## Service Bulletin

### Revised Version: Announcement of DX-D 100 / 100 Wireless System Version 4.4

DD+DIS005.14E

This document contains specific information about system version 4.4 of the DX-D 100 / DX-D 100 Wireless.

Figure 1

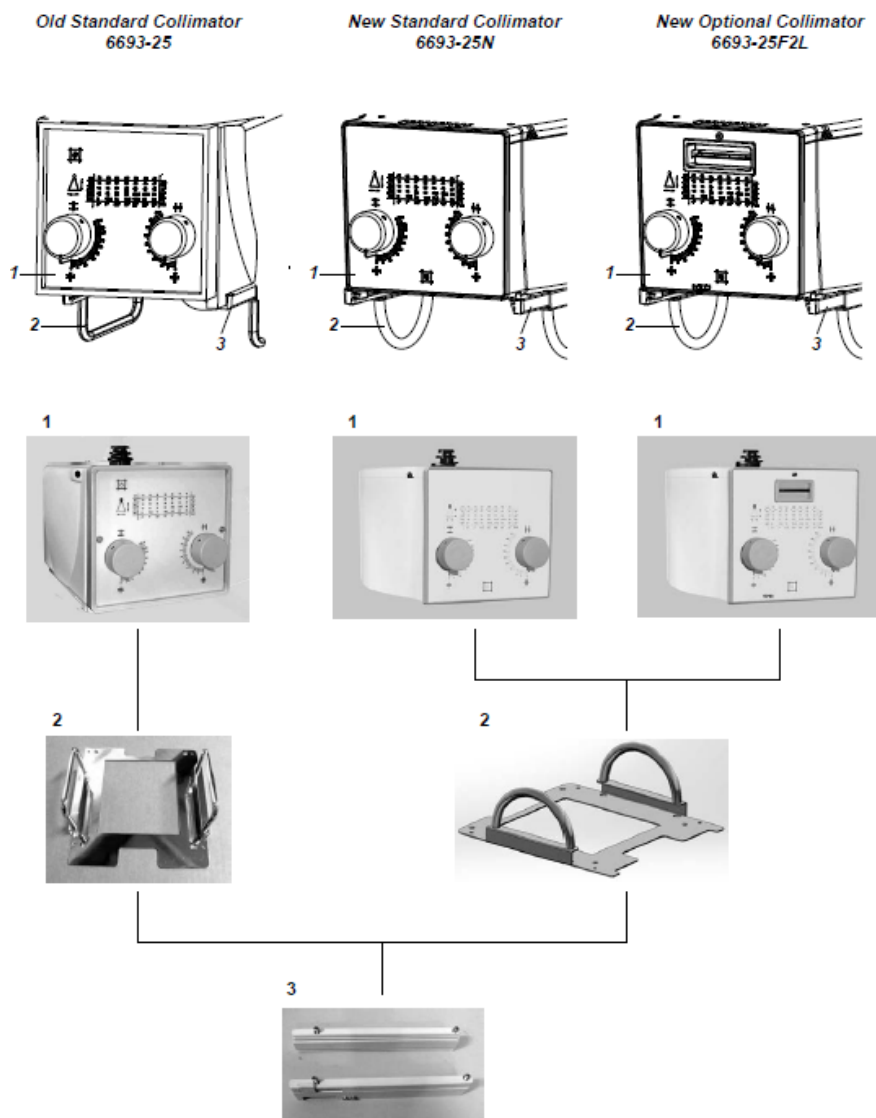
## 1.2 PR1308120002: Additional information about the improved collimator handle design

See below for the different collimators and the improved handle designs:

- Ralco R221 collimator with changed design
- Ralco R221F Collimator available as an option
- Cisco Access Point AIR-SAP-1602E-x-K9
- Metal plate (adapter) for the Cisco Access Point AIR-SAP-1602E-x-K9
